REF: NEX-2300100.00

December 10, 2025

SUBJECT: Response to Comments – Notice of Intent Application
 Proposed Replacement of Brandy Brow Road Culvert over East Meadow River
 Haverhill, MA

USGS Topographic Locus Map of Downstream Floodplain

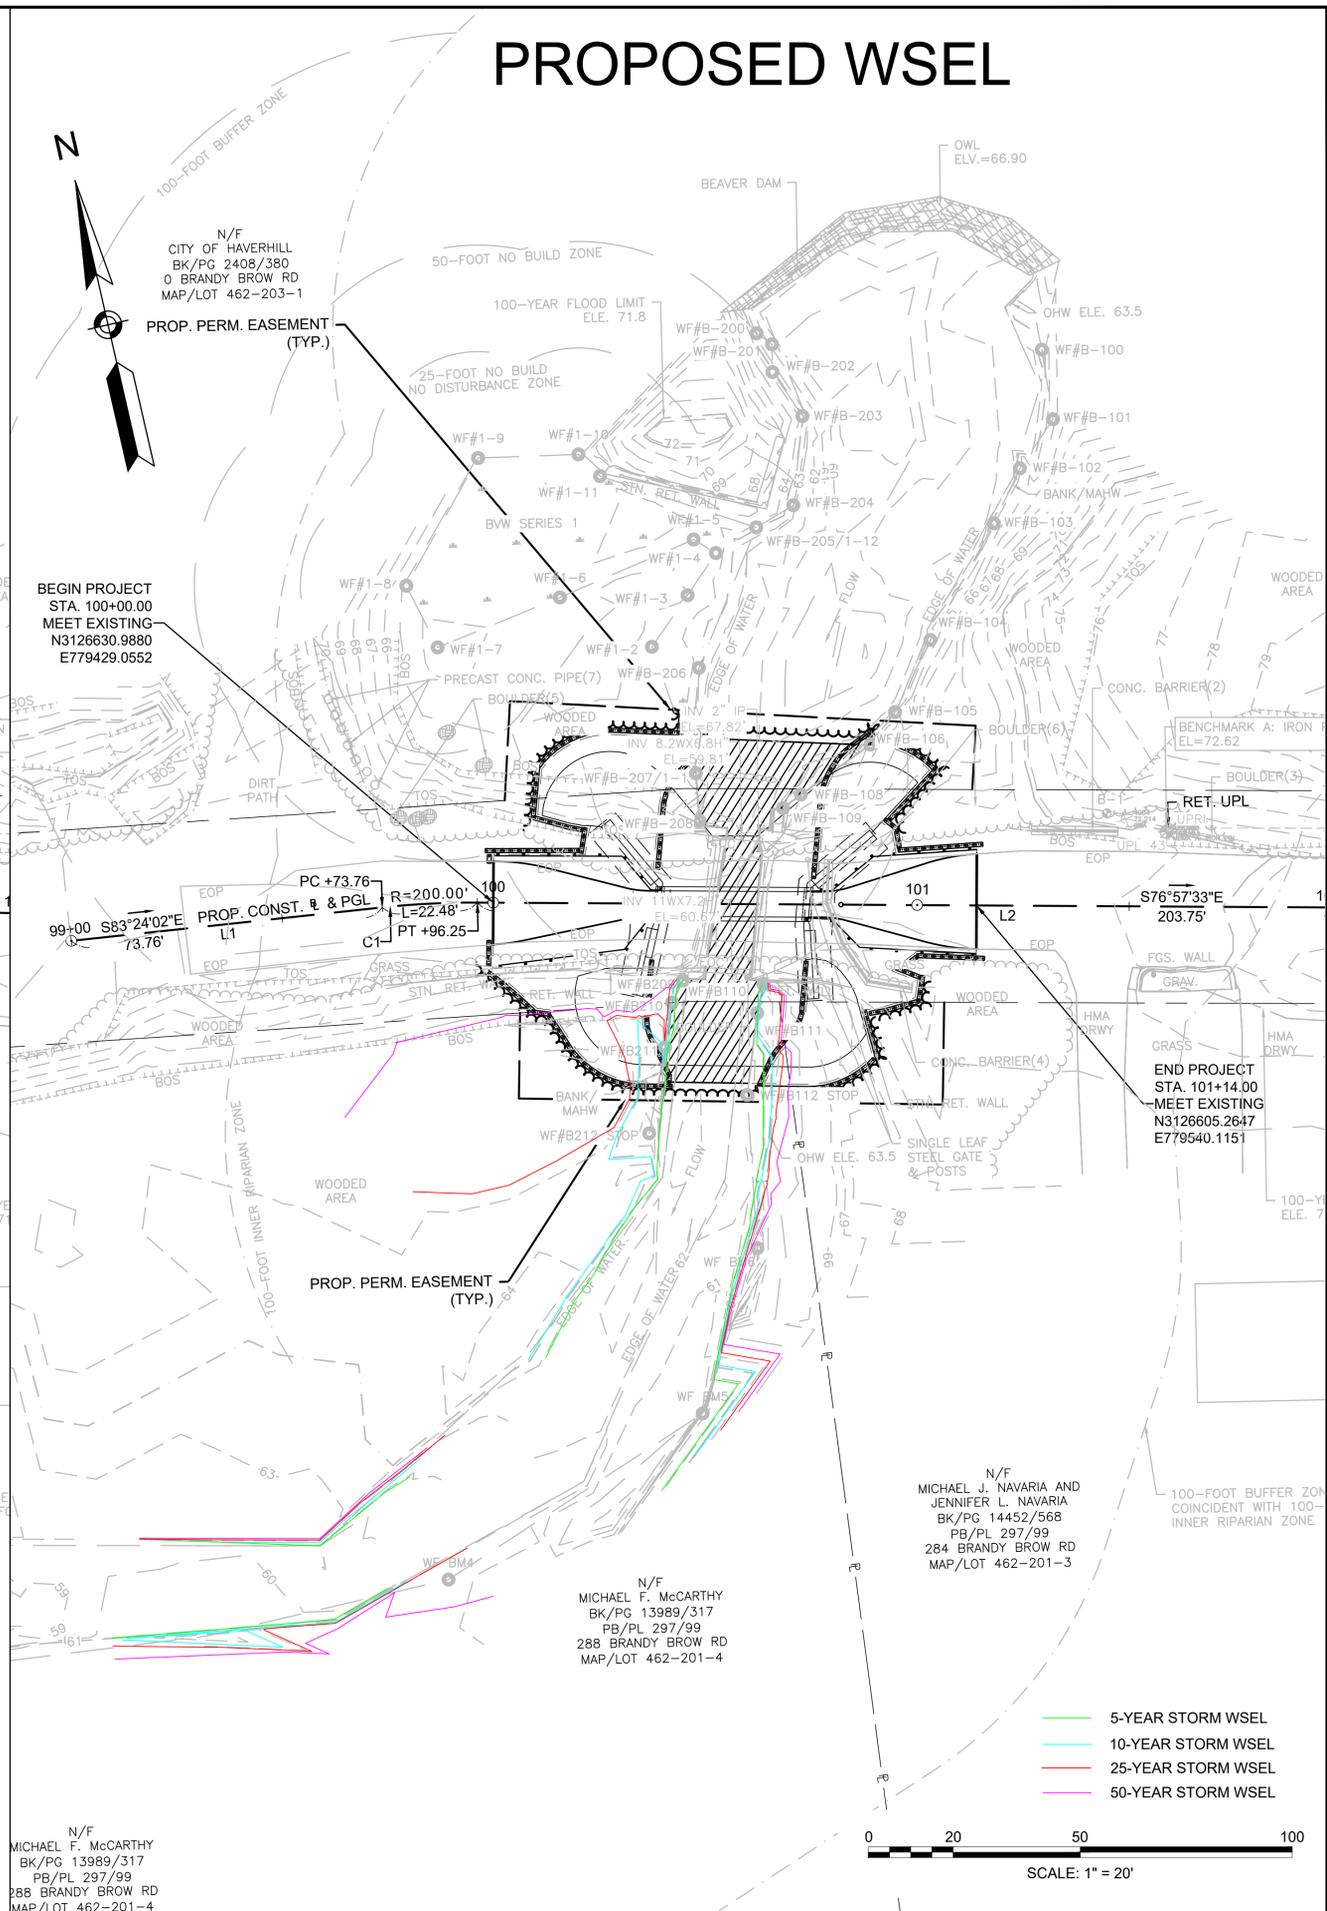
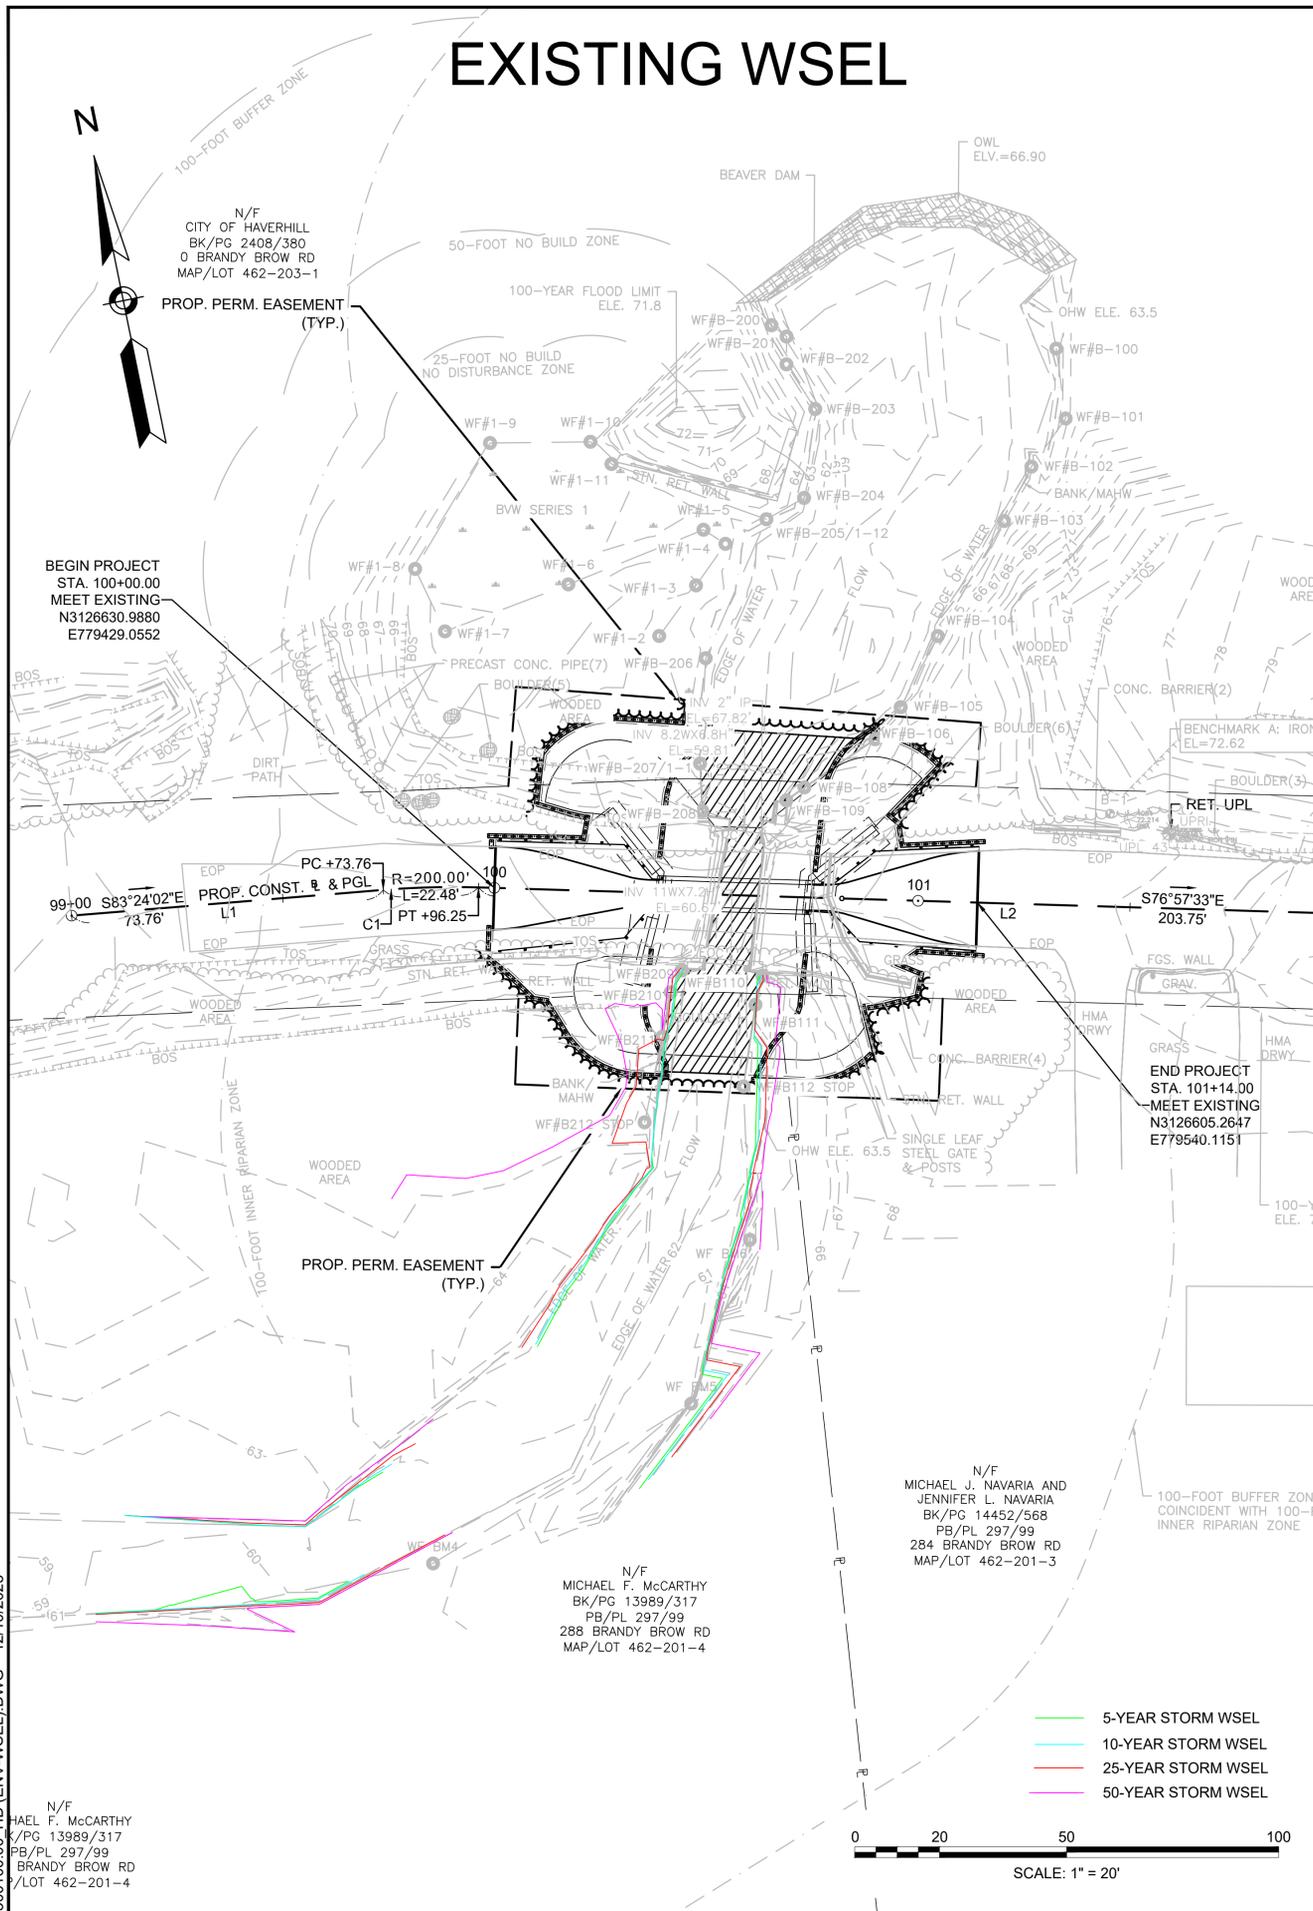
South of the property at 288 Brandy Brow Road, the East Meadow River flows south through undeveloped forest and wetlands for approximately 1.5 miles before reaching the Amesbury Road (Route 110) crossing. Based on the available Federal Emergency Management Agency (FEMA) data, this area represents approximately 84.63 acres of floodplain. A USGS Topographic Locus Map detailing the downstream floodplain limits is provided as an enclosure. GPI anticipates that this area will provide adequate storage for any minor increase in WSEL and that no significant changes in WSEL or flow rate will be observed at the Route 110 crossing.
